## PLANNING DIVISION STAFF REPORT

April 28, 2014 – PM Version

**Plan Title:** University Avenue Corridor Plan: Blending the Past, Present and Future

**Legistar File ID #:** [32635](#)

**Figure 2: Draft Corridor Plan – Recommended Changes to the Comprehensive Plan**

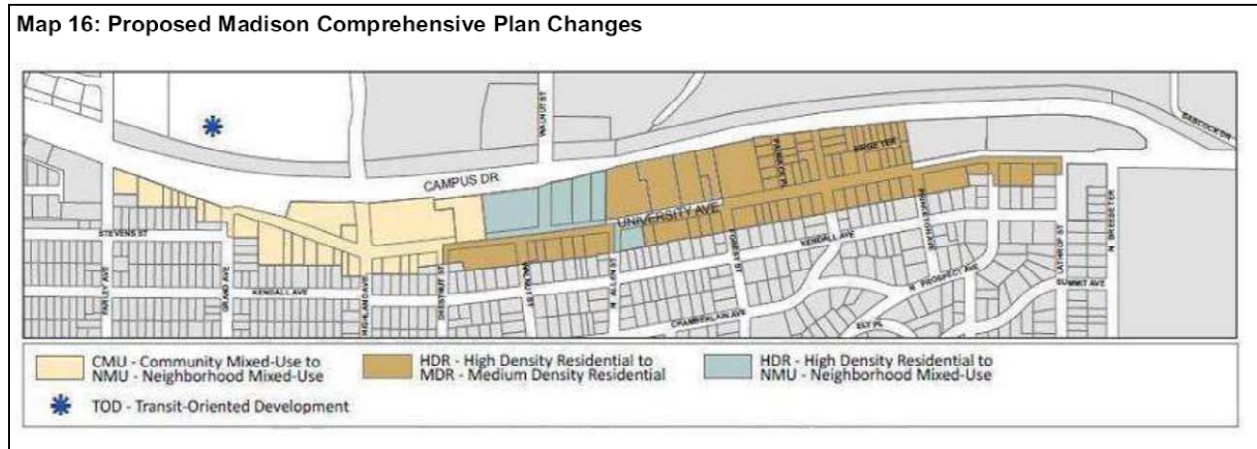
Staff generally supports the changes recommended in the University Avenue Corridor Plan for land use designations along the south side of University Avenue (west of Chestnut along the south side, a change from CMU to NMU; and east of Chestnut, a change from HDR to MDR). These changes would likely result in the maintenance of residential densities along the south side of the corridor similar to what exists today, while still allowing for some redevelopment.

1. Revise Map 16, "Proposed Madison Comprehensive Plan Changes" and associated narrative in the Plan as follows:
  - a) Return the transit oriented development node to its original location between Campus Drive, University Avenue, Highland, and Walnut.

**Figure 4: Planning Staff Response to Draft Corridor Plan Land Use Recommendations**

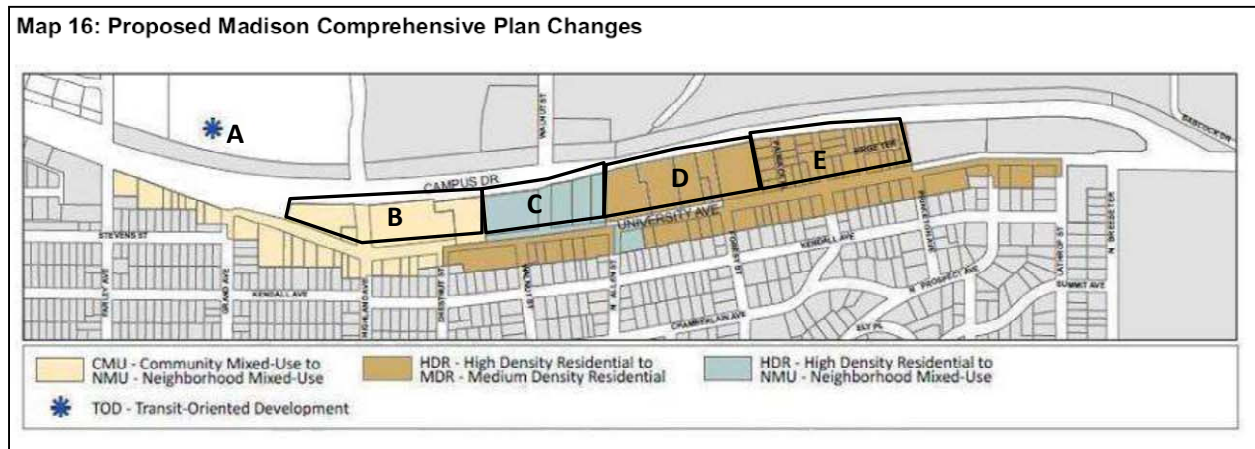
However, staff recommends several changes to the Draft Corridor Plan’s proposed land use designations along the north side of the corridor. The staff recommended changes are explained for the sub-areas identified by the letters A through E in Figure 4.

- A. In the draft Plan, the Transit-Oriented Development (TOD) node designation located within the corridor generally between Highland and Walnut has been relocated outside of the Planning Area northwest of Campus Drive. Staff recommends that this symbol be moved back to its original location, in the area bounded by Campus Drive, University Avenue, Highland Avenue and Walnut Street, as shown in the Comprehensive Plan. The University Avenue/Campus Drive corridor is envisioned as a major transportation and transit corridor, and while the boundaries for a future TOD node are not precisely defined, location within this existing and planned future mixed-use and residential development area seems most appropriate.

- B. Staff considers the recommended change in the mixed use designation from CMU to NMU essentially neutral since the types of intended uses and height and design parameters are defined more precisely within the Corridor Plan in any case. It is appreciated that NMU may more closely reflect the neighborhood vision for the area. Staff can support the recommendation to change the land use designation from CMU (Community Mixed-Use) to NMU (Neighborhood Mixed-Use) in Area B, but only with an additional recommendation supporting high-density residential uses, in either mixed-use or purely residential buildings. This area currently includes the following uses:

- C. Similarly, staff can support the recommendation to change the land use designation from HDR (High Density Residential) to NMU (Neighborhood Mixed-Use) in Area C, but only with the assumption that high-density residential uses will be supported within either mixed-use or purely residential redevelopment. Staff notes that, with some commercial spaces in the corridor already struggling, it is not necessary to see this area developed with mixed-use buildings (although some ground floor commercial space would be fine), and both mixed-use buildings and purely residential buildings can be supported. The area currently includes the following uses:

- D. Staff does not support the recommendation to change the land use designation in Area D from HDR (High Density Residential) to MDR (Medium Density Residential), a recommendation that would mean that future residential densities supported by the plan would be only approximately half the existing density. The area currently includes apartment buildings ranging from 3 to 5 stories in height as follows:

- E. Staff does not support the recommendation to change the land use designation in Area E from HDR (High Density Residential) to MDR (Medium Density Residential), but recommends that this unique area remain at a similar density as exists today. Most properties in this area are very small lots with two-story residential buildings in varying states of repair. While redevelopment of the area would be supported by staff, maintenance of the existing lot pattern and rhythm of buildings is recommended. Staff recommends that a maximum residential density of 50 dwelling units per acre for this area be specified on a revised Future Land Use Map. This density is close to the existing density, but should still provide opportunities for lot by lot redevelopment in

- b) For areas B and C shown on Page 5 of this report, which are recommended for the land use designation of "NMU (Neighborhood Mixed Use), indicate that residential densities exceeding 100 units per acre are supported.

- c) Maintain the HDR (High-Density Residential) land use designation for areas D and E, noting for area D that densities of 80 units per acre or above are supported, and for area E that densities of up to 50 units per acre are supported.

**Figure 6: Planning Staff Response to Draft Corridor Plan Building Height Recommendations**

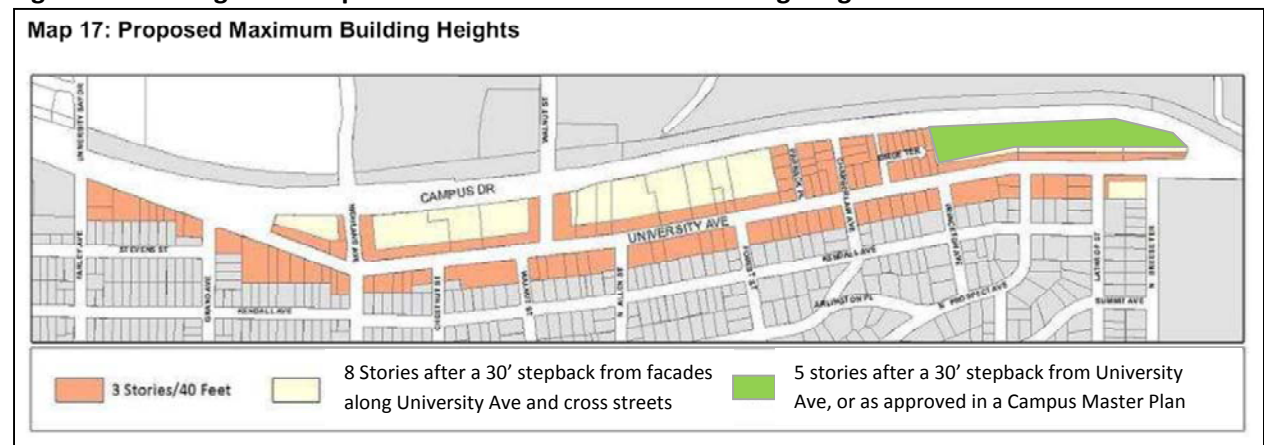
On the south side of University Avenue, staff recognizes that a three-story height limit may present challenges to redevelopment, but believes a three-story height to be adequate, particularly because these lots are relatively shallow and abut single-family residential properties behind them. On the north side of the corridor, staff supports the three-story height limit for the facades fronting on University Avenue and the cross streets, and also for the area from the west side of Paunack Place to the eastern end of Birge Terrace.

However, staff does not support the recommended four to five story maximum height on the deep properties bounded by University Avenue and Campus Drive. Although not a substantive issue, staff notes that Map 17 suggests that a conditional use requirement can be triggered by the Plan recommendation itself. Instead, conditional use thresholds are established in the zoning code. This area is currently zoned TSS, TR-U1, and TR-U2. Conditional uses will be required in the TSS District for any building over three stories, and in the TR-U1 and TR-U2 District, for any building with over 8 residential units. Thus, the vast majority of redevelopment proposals will likely require conditional use review in any case.

Staff believes that with a three-story height limit on the University Avenue facade, these properties could support heights up to six to eight stories with a sufficient stepback from the facade. This is an area very appropriate for greater densities, as discussed above, and additional building height is not likely to have shadow or “canyonization impacts” on the residential neighborhood to the south, so long as it is stepped back from University Avenue.

Staff also recommends that the Plan set a 5-story maximum height limit as allowed in the TR-U1 Zoning District for the University of Wisconsin owned properties in the northeast corner of the Planning Area. However, staff recommends that the Plan acknowledge that a future Campus Master Plan that may seek taller heights, and if approved by the Common Council that this Plan should be amended to reflect that decision.

To incorporate these changes, staff recommends that Map 17 be revised as shown in Figure 6 below:

2. Revise Map 17, "Proposed Maximum Building Heights", as shown in Figure 6 on Page 9 of this report, and change associated narrative in the Plan.
3. Eliminate Map 18, "Proposed Minimum Front and Rear Yard Setbacks", and eliminate any narrative in the Plan pertaining to rear yards differing from the underlying zoning requirements. Provide narrative in the Plan recommending that in areas where front setbacks are not required by underlying zoning, a 5-foot front setback should be provided to create space for streetscape amenities in front of commercial uses and for landscaping in front of ground floor residential uses.

**Figure 7: Draft Corridor Plan Recommendations for Building Setbacks**

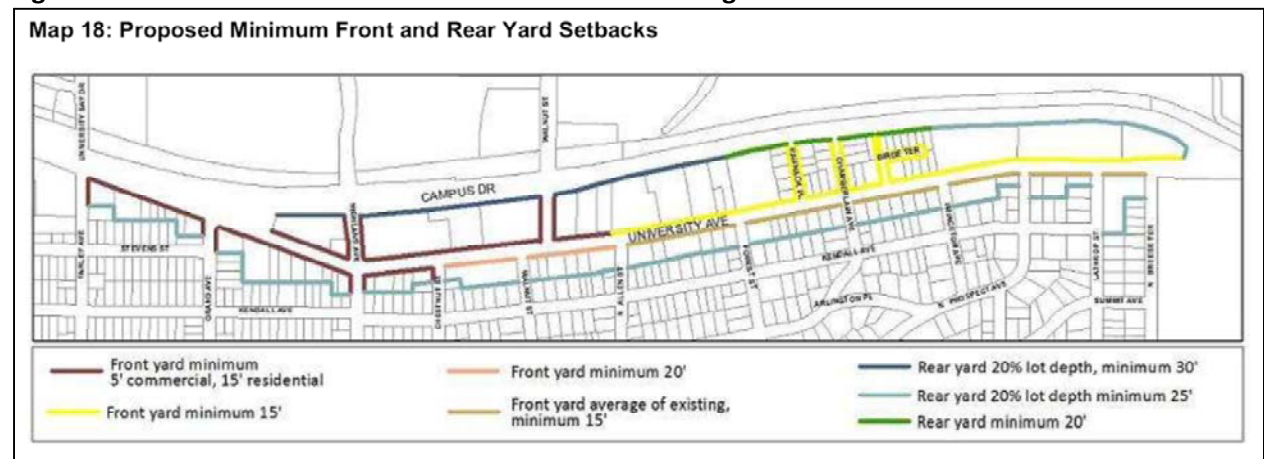
In general, staff considers the setbacks established by the zoning districts to be appropriate, and recommends that many of the different setback recommendations in the draft plan be eliminated or revised, as described in detail below.

Staff recommends eliminating all of the rear yard setback recommendations and deferring to underlying zoning requirements, which generally range from 20 to 25 feet for the zoning districts in the area, but could be as low 20%-25% of the lot depth, which would lead to lesser rear yard requirements on lots under 100 feet deep. Staff does not believe that it makes sense to create deep rear yard setbacks along Campus Drive (the Plan effectively recommends rear yards greater than 40 feet, when taking into account the 200+ foot deep lots in this area), but would rather see development as close to Campus Drive as the rear yard requirement in the base zoning district would allow. This is an area that will have few if any impacts on area residents, and deeper setbacks would not necessarily result in quality usable open spaces abutting Campus Drive.

With regard to the front yard setbacks recommended in the Plan, staff notes that the 15-foot recommended front yard setbacks on both sides of University Avenue east of North Allen Street is consistent with the requirement in the underlying TR-U1 and TR-U2 Zoning districts, and is thus unnecessary to include in the Plan. Staff does not support the 20-foot setback recommended just west of North Allen Street on the south side. This is greater than the 15-foot setback required in the underlying TR-U1 zoning district, and also greater than the existing 15-foot setback of most of the buildings along this stretch. Staff believes that this can also be eliminated from the Plan.

Staff could support the recommended 5-foot front yard setback for commercial and mixed-use buildings on both sides of University Avenue and the cross streets in the western portion of the corridor, although it is important to note that the underlying TSS (Traditional Shopping Street) zoning district in this area does not require a front yard setback. Staff notes that since some of these lots are relatively shallow, the provision of a front yard setback will likely push buildings back further toward the rear property line than they might otherwise be, but the rear yard setback would apply in any case. If this recommended 5-foot setback is maintained, staff strongly recommends that it pertain to all building types, rather than having the deeper 15-foot setback requirement for residential buildings. This will allow for a consistent street frontage, regardless of ground floor use, while still allowing for a variety of treatments between the building and the sidewalk (structured landscaped areas between the sidewalk and residential buildings, and hardscaped areas to accommodate benches, bicycle parking, etc. in front of commercial or mixed-use buildings).
